Tri-Prop, LLC
*Opening Doors for the General Aviation
Community*

RE: A1 Hot Spot Mitigation

The Refined Preferred Alternatives does not reflect the modifications required to mitigate Hot Spot A1 at the Aurora Airport. Although the Hot Spot will be removed when the runway is extended, that may be years in the future. It is my understanding the mitigation plan must be reflected in the Master Plan before it can be included on the Airport Layout Plan and approved.

Attachment item 21, FAA 7460-1 dtd 06/09/2023

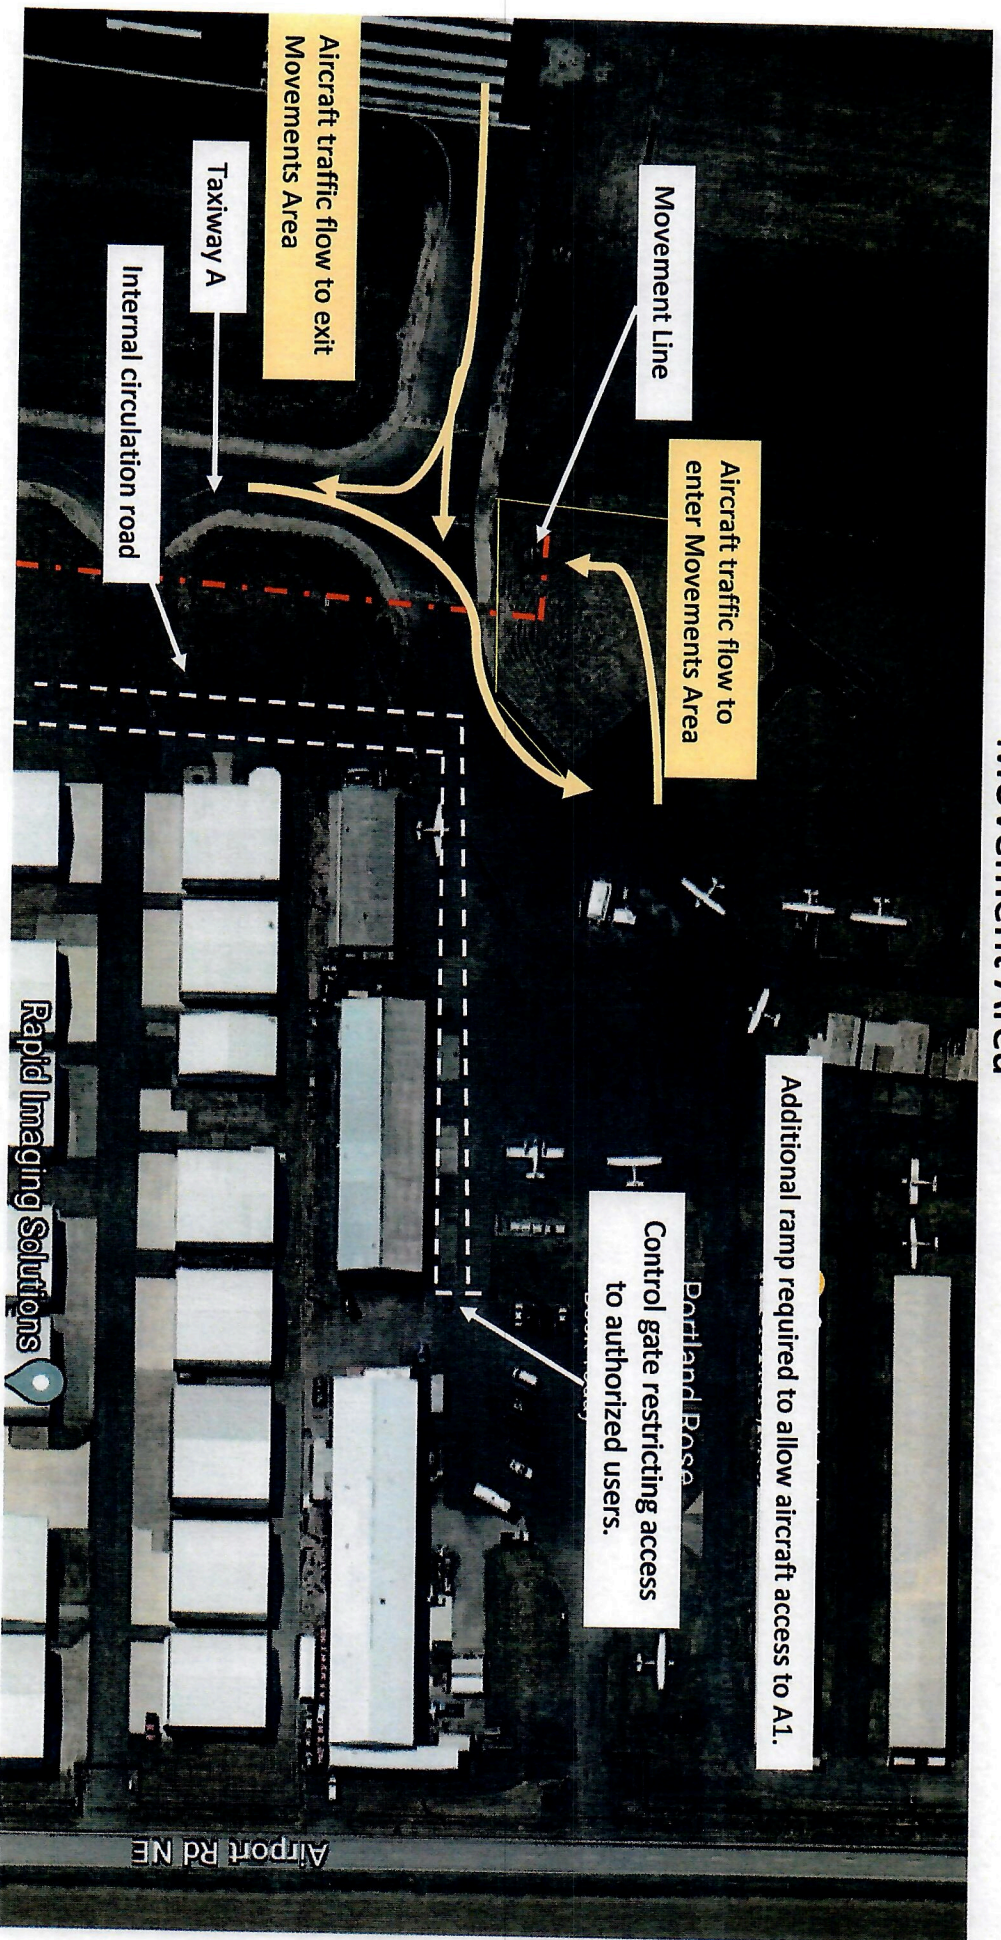
Add additional paving for a taxi lane to eliminate ground vehicle & aircraft conflicts to access Taxiway A at the Aurora Airport, allowing the completion of the internal circulation road outside the airport Movement Area.

Proposed Taxilane and Internal circulation road
with proper setback and aircraft flow to and from the
Movement Area

FIGURE 11: REMOVE DIRECT ACCESS - NORTH END

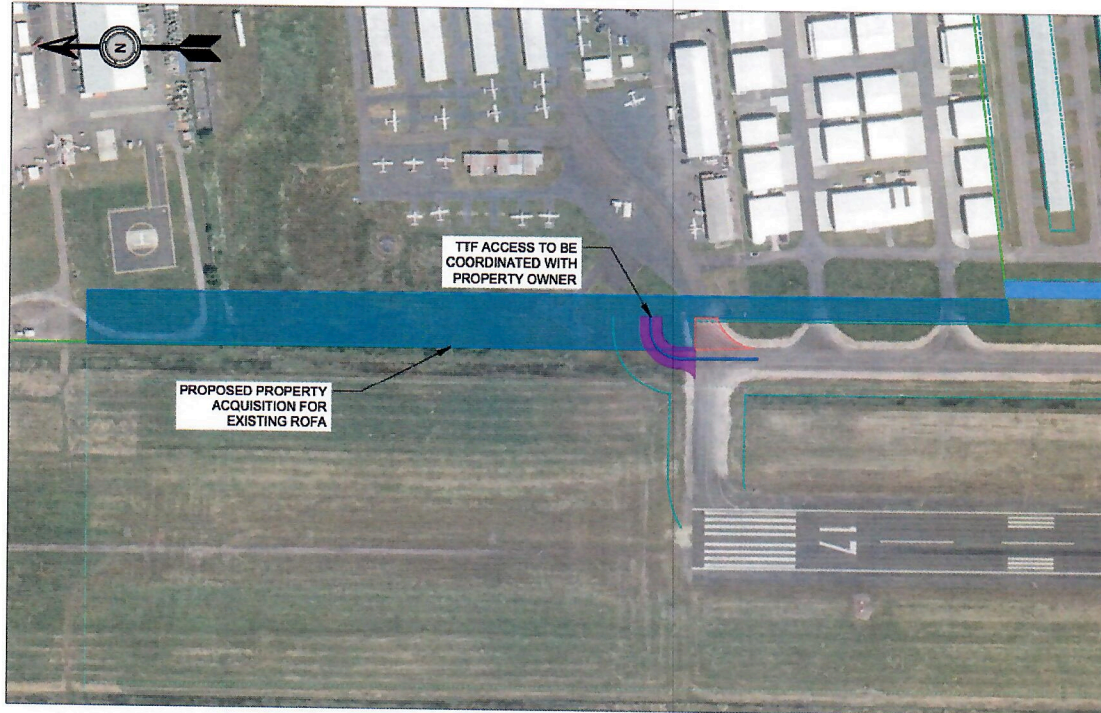
Figure 11 depicts a proposed reconfiguration of the existing TTF taxilane connection to Taxiway A1. The change in configuration would create a new taxi route between the adjacent apron and the runway, including a 90-degree turn to access Taxiway A and a second 90-degree turn to access Taxiway A1. This would eliminate the direct aircraft access configuration on Taxiway A1. The proposed changes require a new taxiway section and coordination with the adjacent private property owner. It is noted that a portion of this private property is also located in the ROFA for the existing Runway 17/35, which is recommended for property acquisition to meet FAA standards.
